**Recommendations of the Risk Informed Steering Committee
Working Group on PRA Technical Adequacy**

December 2014

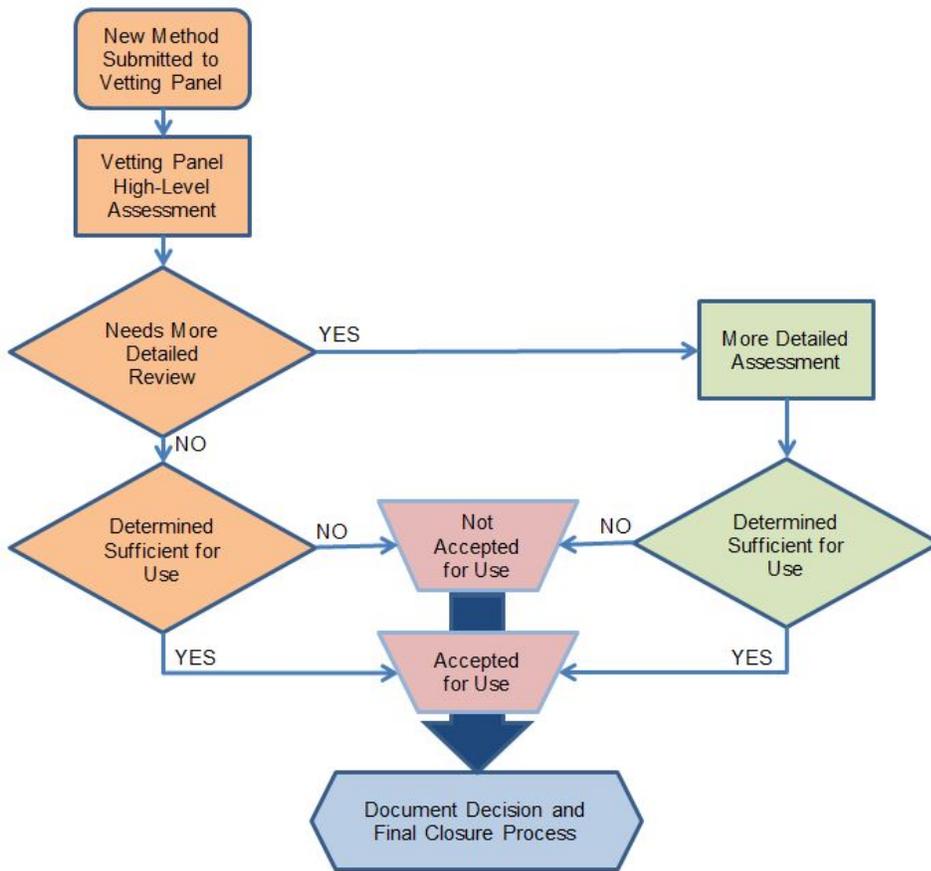
Comment [NRC12]: The narrative about the vetting panel needs to come before or have integrated into it the description of the process options.

Comment [NRC13]: The NRC agrees that more detailed guidance (similar to Appendix 1) is needed as part of the pilot process to determine its practicality and revise the guidance as appropriate.

However, for this part of the discussion in the whitepaper, the NRC staff considers a high-level conceptual flowchart to be more useful for explanatory purposes.

Comment [NRC17]: As written, this appears to be inconsistent with the Appendix 1 figure. This description seems to imply that a method that does not pass a peer review or meet RG 1.200 in a gap assessment can still be used by a licensee in an application so long as the licensee addresses the failings of the method, as identified in the peer review or gap assessment. The Appendix 1 figure implies that such a method would not be accepted for use.
